# TECHNICAL SERVICE BULLETIN

## Ting, Pop Or Clicking Noise From The Front Or Rear Wheel Hub When Accelerating Or Applying Brakes (Torque Reversals)

**22-2395**

<b>Ford</b> 2022-2023 F-150 Lightning
--

Figure 1

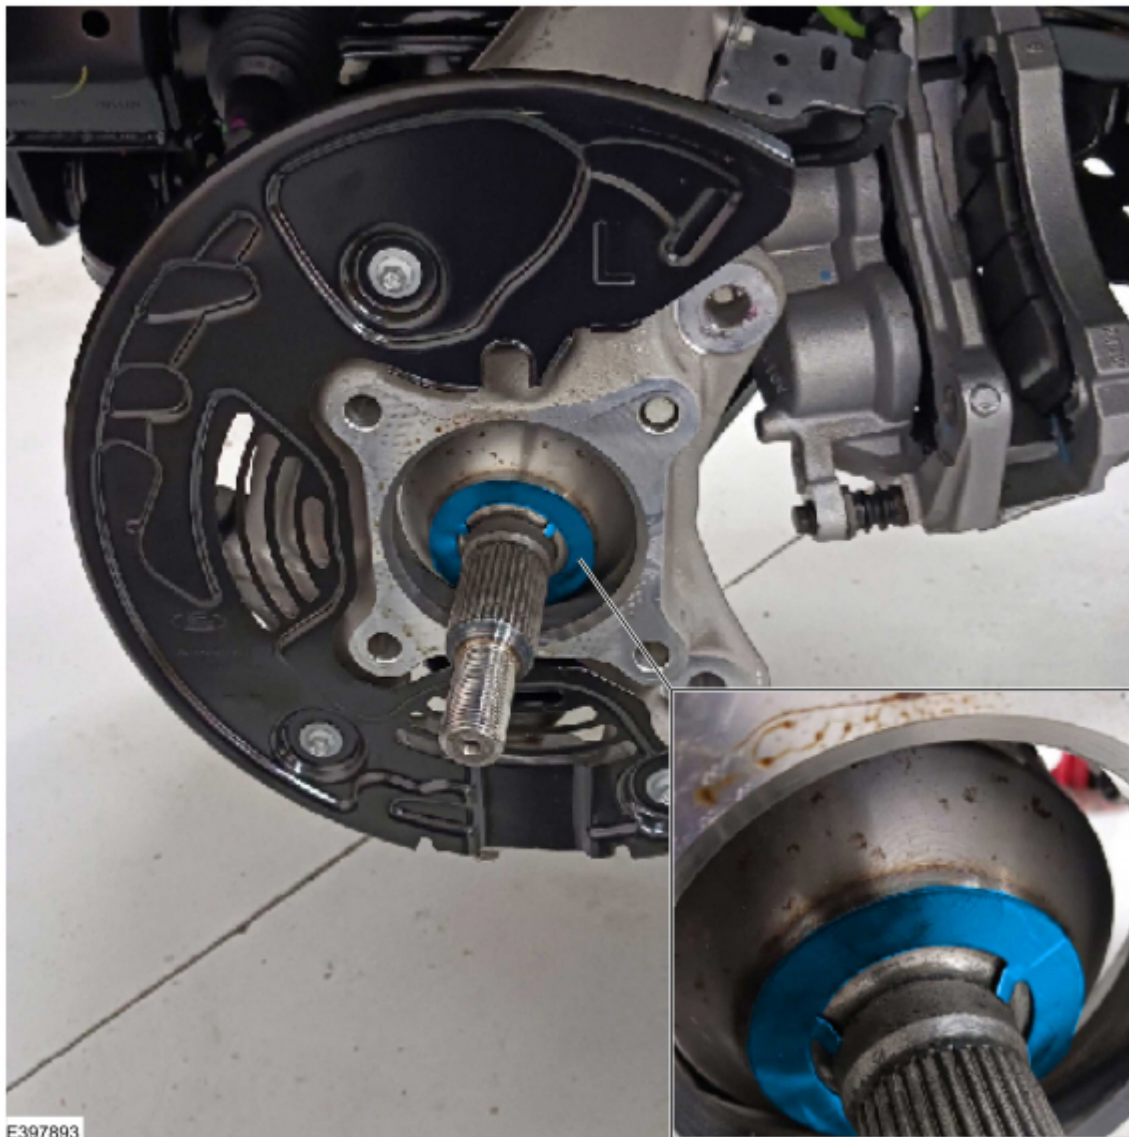
1. Drive the vehicle to verify the concern, accelerate/apply brakes or shift from forward to reverse (torque reversals).
2. Does the vehicle exhibit ting, pop or clicking noise from the front or rear?
  - (1). Yes - add the anti-ting washer to both left and right halfshaft to hub interface for front and/or rear of the vehicle that exhibits the noise. (Figure 1) Refer to the Workshop Manual (WSM) 204-02 Rear Suspension - Wheel Bearing and Wheel Hub > Electric Procedure or WSM 204-01B Front Wheel Bearing and Wheel Hub. Install the anti-ting washer between the wheel hub and axle shaft interface and reassemble.
